PART-21 REPORT - VALVE SEAT LEAKAGE DEFECT

Fisher Information Notice: FIN 2015-01

Subject: Fisher Type 461 Valve Plug Machining

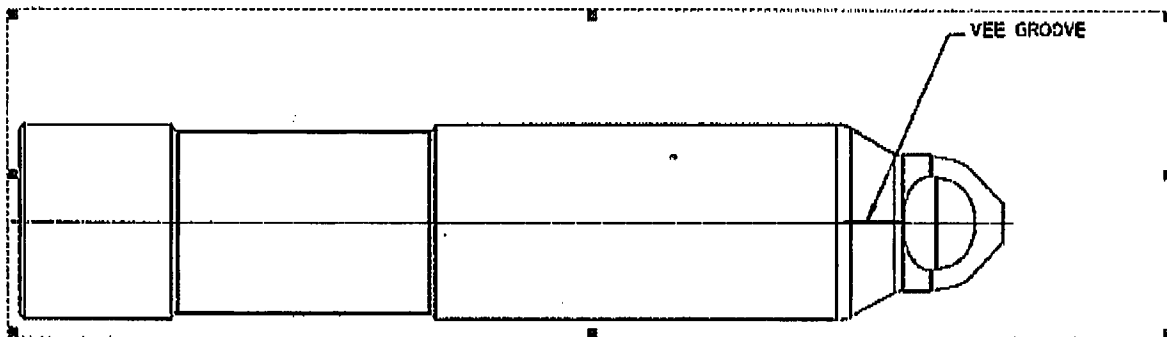
A valve plug originally supplied as a spare parts order was returned to Fisher after the customer discovered a machining error was present on the plug. The Type 461 valve plug has a groove machined across the seating surface of the plug. This groove is required to provide a controlled leak rate thru the valve when the plug is on the seat. The issue recently identified shows that the machined groove did not extend through the full length of the seat. This could lead to a situation in which the intended / required leakage for this design is not fully achieved.

Action Required: Evaluate any affected Type 461 valve plugs in inventory to ensure the machined groove extends across the plug seating area.

Fisher is revising the affected drawings for increased clarity and implementing appropriate corrective actions per CAR 1727.
